# HIGHWAY WORK PROPOSAL

Proposal Number: **016**

<u>STATE ID</u>	<u>FEDERAL ID</u>	<u>PROJECT DESCRIPTION</u>	<u>HIGHWAY</u>	<u>COUNTY</u>
2590-04-71	WISC 2025314	C Milwaukee, W Lisbon Avenue, W Burleigh St to N 100th St	LOC STR	Milwaukee

## ADDENDUM REQUIRED ATTACHED AT BACK

PROJECT NO: 2590-04-71	HWY: W. LISBON AVENUE	COUNTY: MILWAUKEE	CONSTRUCTION DETAILS	SHEET 22	E
FILE NAME: W:\SPRISON\AVE BURRIGH TO 100TH\021001_CD.DWG	DATE: 1/28/2025 11:52 AM	PLOT BY: BEGEMAN, SCOTT	PLOT NAME: 5'x10.5' FT	WOOD/CARDS SHEET 42

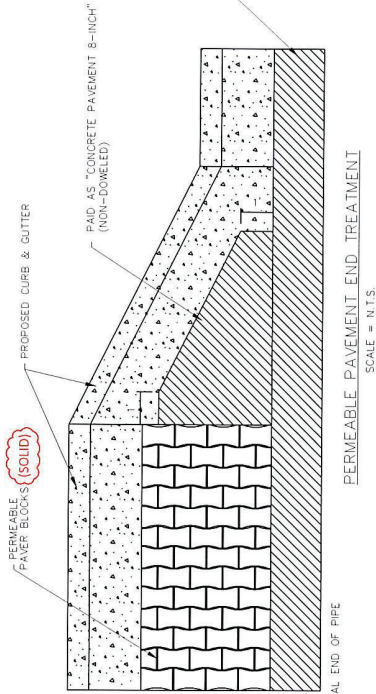
Addendum No. 01  
ID 2590-04-71  
Revised Sheet 22  
January 29, 2025

Addendum No. 1  
ID: 2590-04-71  
Revised Sheet 22  
January 28, 2025

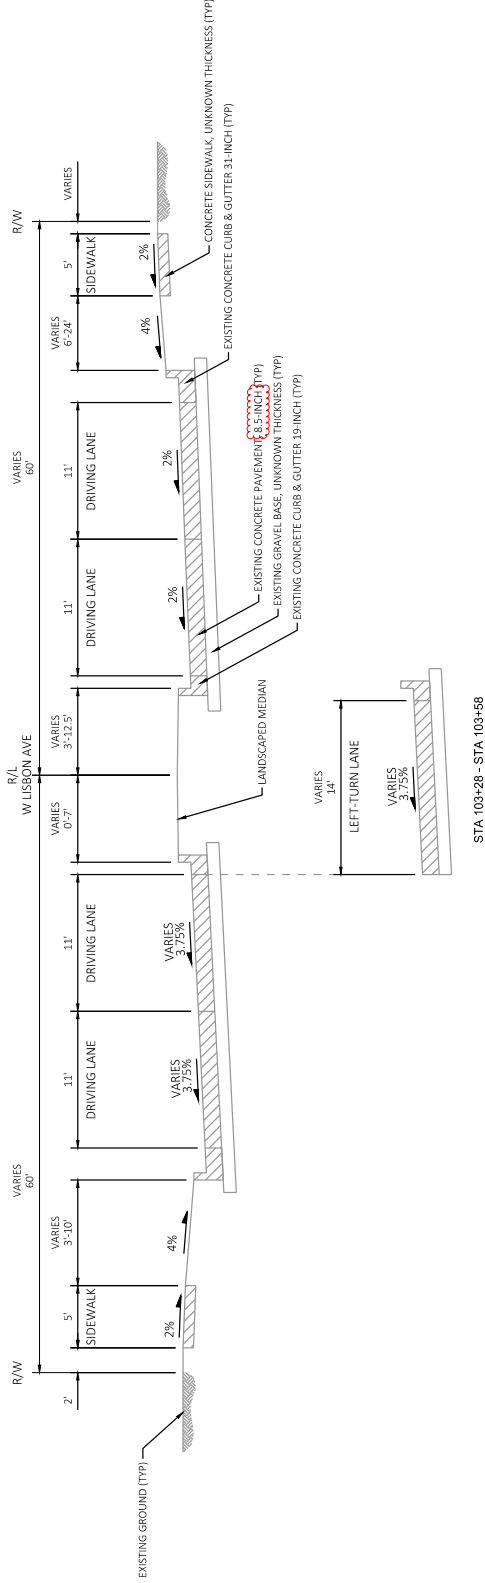
Addendum No. 03  
ID 2590-04-71  
Revised Sheet 4  
February 4, 2025

NOTE:  
CONTRACTOR TO PERFORM THIN ASPHALTIC OVERLAY  
ON WEST LISBON AVENUE EASTBOUND LANES FOR TRAFFIC STAGING.  
SEE CONSTRUCTION STAGING/TRAFFIC CONTROL PLANS.

**EXISTING TYPICAL SECTION**  
WEST LISBON AVENUE (LOOKING EAST)  
STA 194+60 - STA 211+03

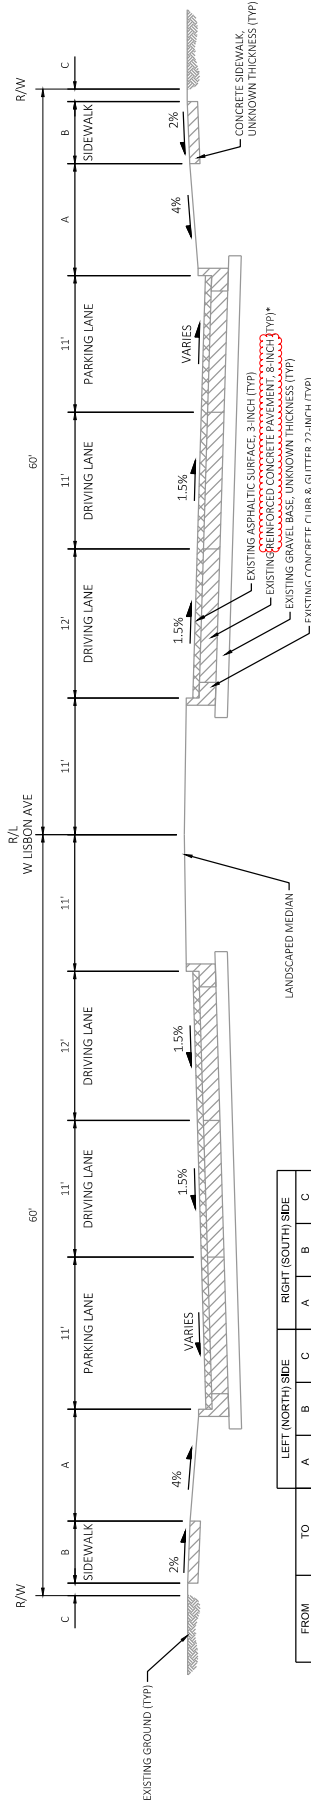
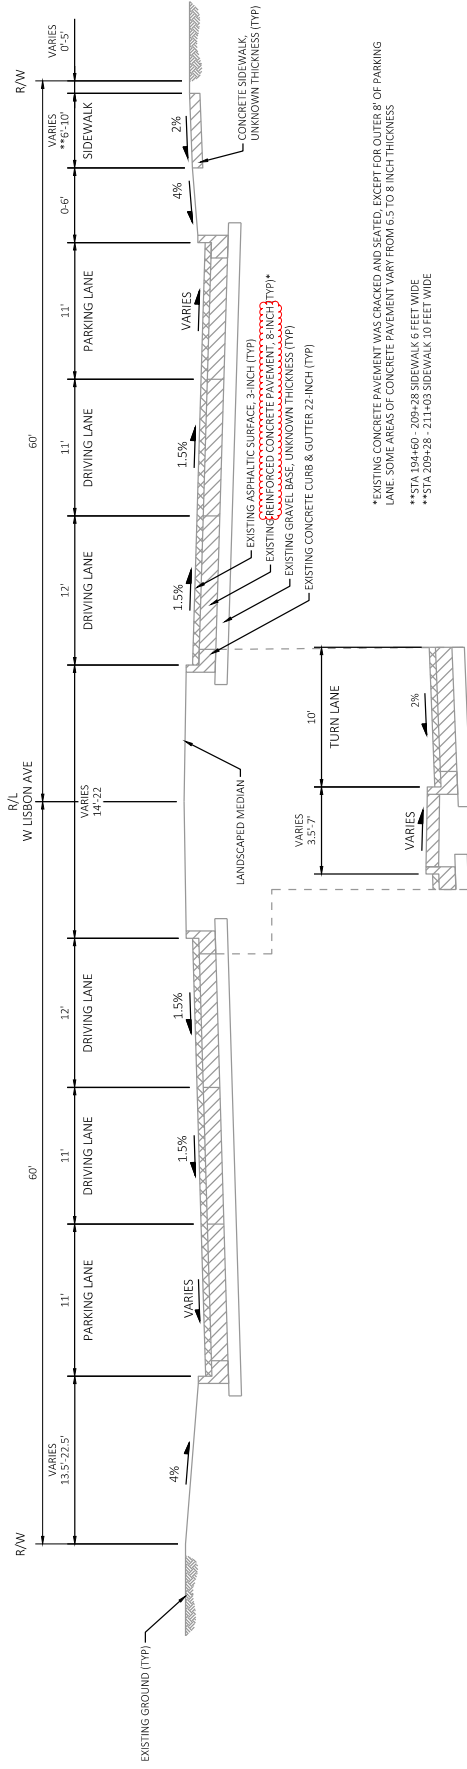
20	Typical Sections - Finished (revised existing concrete pavement thickness information and noted doveled pavement on 76 <sup>th</sup> Street to match existing pavement)
21	Typical Sections - Finished (revised existing concrete pavement thickness information)

\*EXISTING CONCRETE PAVEMENT WAS CRACKED AND SEALED, EXCEPT FOR OUTER 8' OF PARKING LANE. SOME AREAS OF CONCRETE PAVEMENT VARY FROM 6.5 TO 8 INCH THICKNESS

\*EXISTING CONCRETE PAVEMENT WAS CRACKED AND SEALED, EXCEPT FOR OUTER 8' OF PARKING LANE. SOME AREAS OF CONCRETE PAVEMENT VARY FROM 6.5 TO 8 INCH THICKNESS

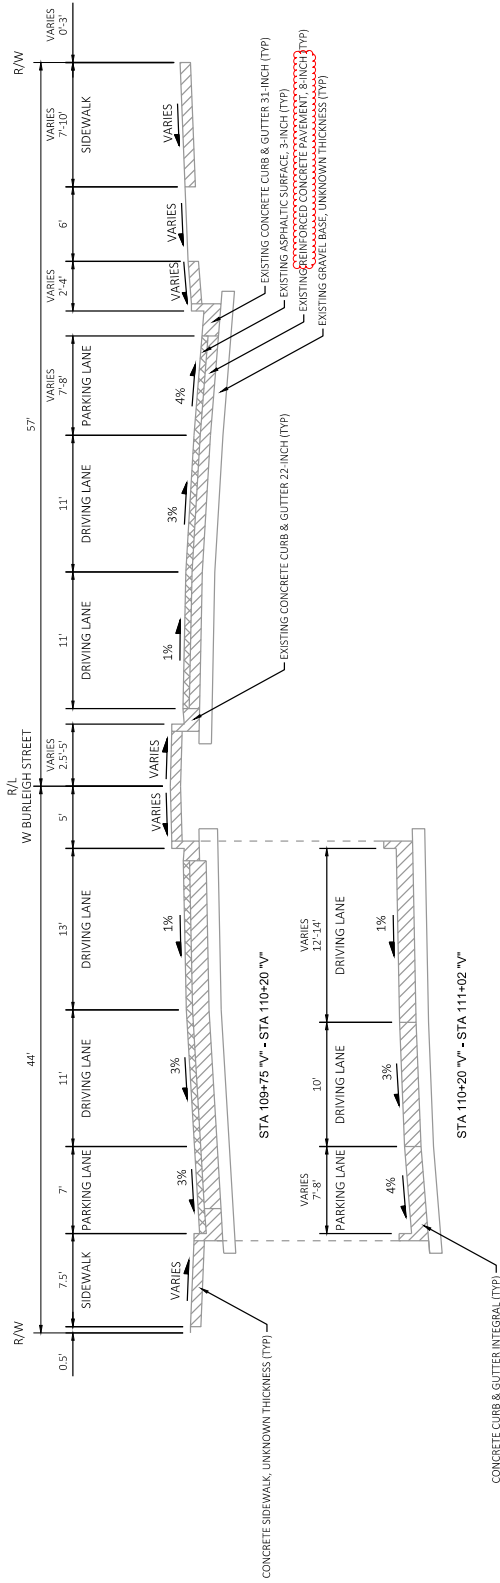
Addendum No. 03  
ID 2590-04-71  
Revised Sheet 9  
February 4, 2025

PROJECT NO: 2590-04-71	HWY: W LISBON AVENUE	COUNTY: MILWAUKEE	TYPICAL SECTIONS - EXISTING	SHEET 11	E
FILE NAME: Y:\33\X\3889 DP 21 LISBON AVE MIL CAD\05\2590\04\01\Sheet9P\AN\020301-TS.DWG	LAYOUT NAME: 020308-15	2/9/2025 1:13 PM	PLOT BY: AUSTIN ROSA	1 IN=10 FT	WISDOT/CADD 5-SHEET 42

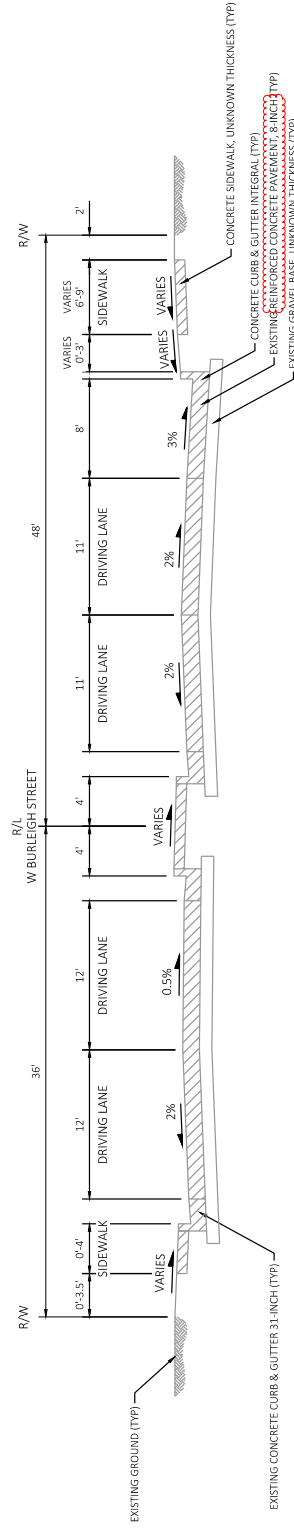
Addendum No. 03  
ID 2590-04-71  
Revised Sheet 11  
February 4, 2025

PROJECT NO: 2590-04-71	HWY: W. LISBON AVENUE	COUNTY: MILWAUKEE	TYPICAL SECTIONS - FINISHED	SHEET 15	E
FILE NAME: Y:\33\X\3889 DP 21 LISBON AVE MIL CAD\05\2590\04\01\002590-04-71.DWG	DATE: 2/2/2025 1:13 PM	PLT BY: AUSTIN ROSA	PLT NAME: 1 IN=10 FT	PLT SCALE: 1 IN=10 FT	WISDOT/CADD SHEET 42

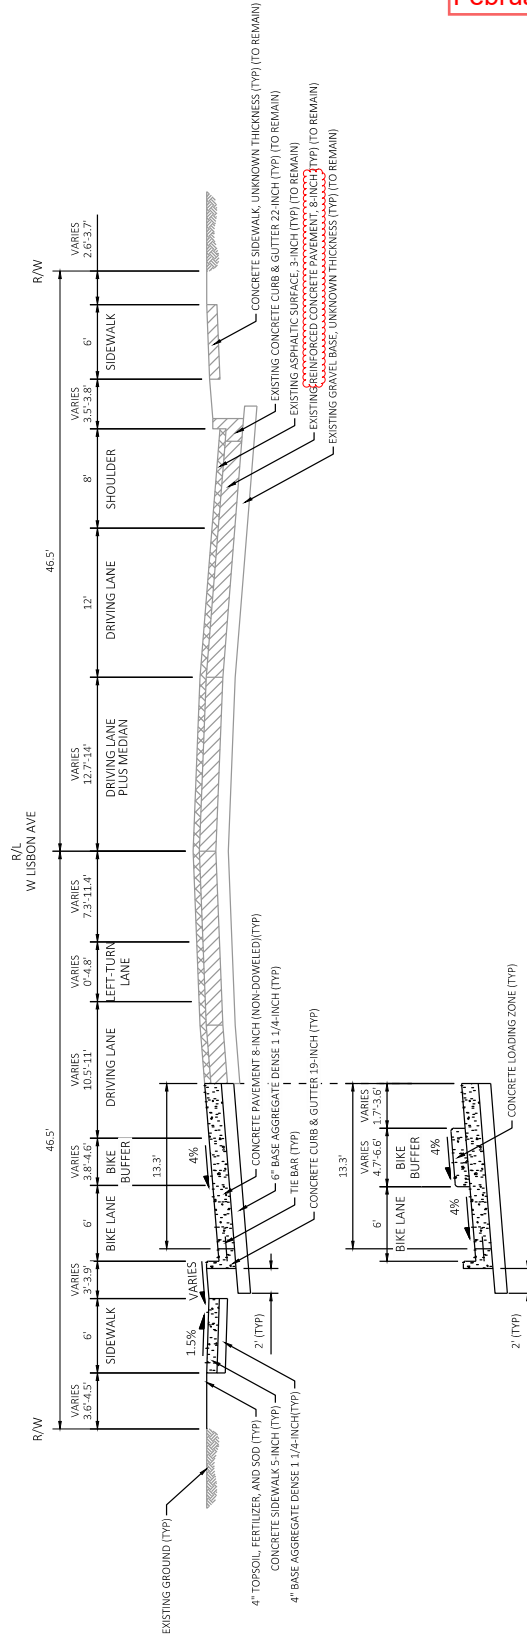
Addendum No. 03  
ID 2590-04-71  
Revised Sheet 15  
February 4, 2025
